Re : Southern Comfort Lounge
2209 Gause Blvd. East
Slidell, LA 70461
St. Tammany Parish

Re: Southern Comfort Lounge Water Supply
New Water System for Addition to Inventory

Slidell, Louisiana
St. Tammany Parish
DES Number 15-021

Plans and specifications of the above named project have been reviewed. The plans are **DISAPPROVED** pending resolution of the following items which appear to be in conflict with applicable provisions of the Louisiana Administrative Code (LAC), or upon which further information is needed.

Small Water System Configuration

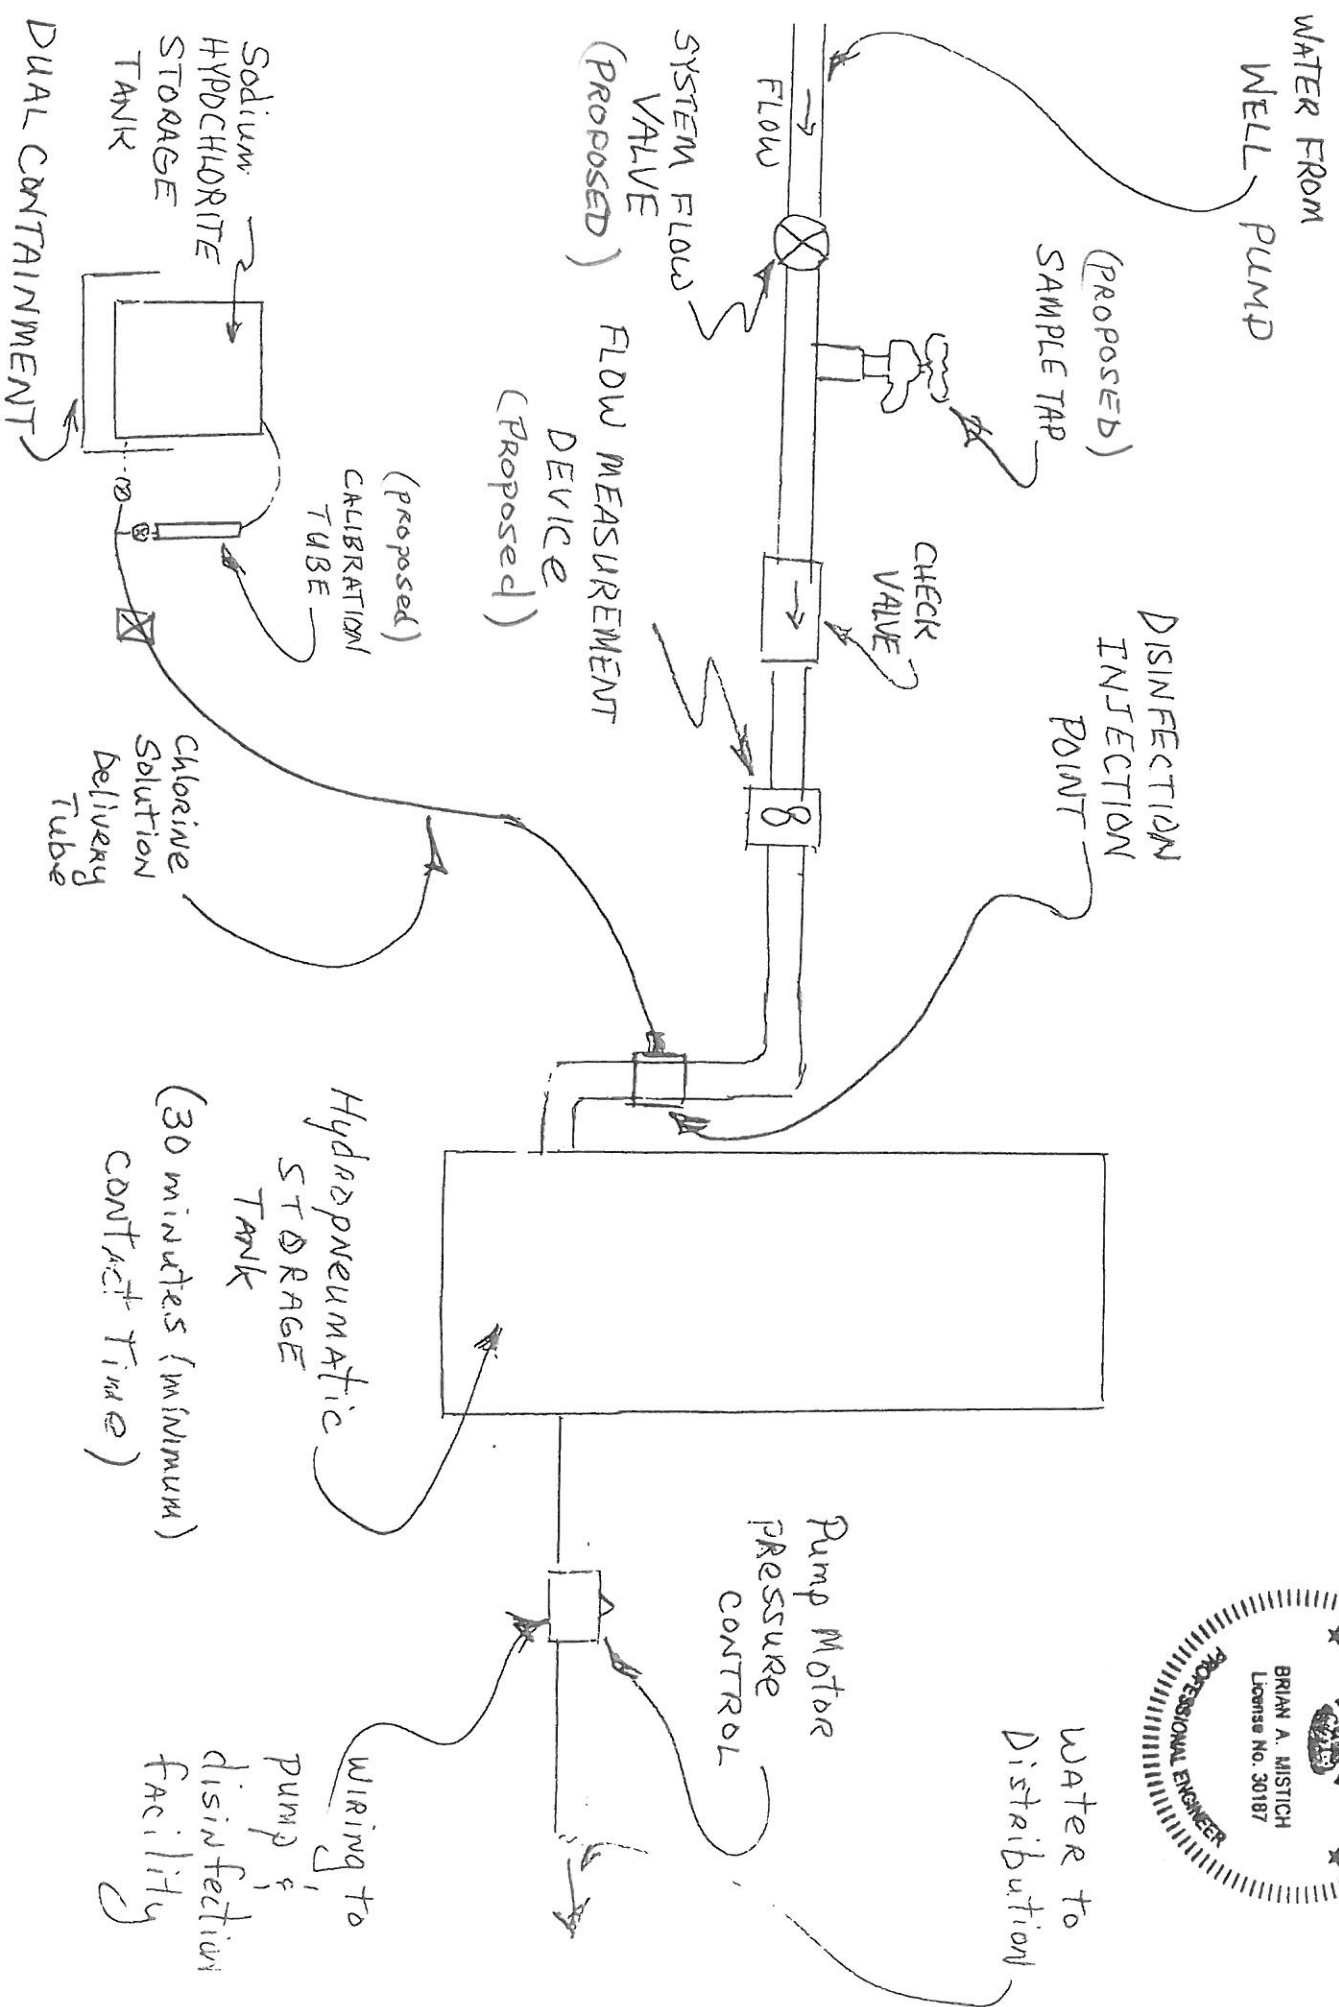
4. Please specify if the hydropneumatic tank meets ASME code requirements per Recommended Standards for Water Works (RS), 2003 Edition Section 7.2. Please revise and resubmit plans accordingly.

5. Per Section 7.2.3 of RS, the hydropneumatic tank shall have bypass piping to permit operation of the system while the tank is being repaired or painted. Please revise and resubmit plans accordingly.

6. The ESPA Water Storage page 2/2 states that the hydropneumatic tank will have no sight glass. Please specify if an automated control to maintain the proper water-to-air ratio in the hydroneumatic tank is provided. Please revise and resubmit plans accordingly.

7. Please provide the calculation of chlorine contact time to ensure at least 30 minutes contact time prior to the first customer. Show all reduction factors utilized specific to the tank construction used in the calculations. Please submit the calculation showing that the 30 minute contact time is provided for review.
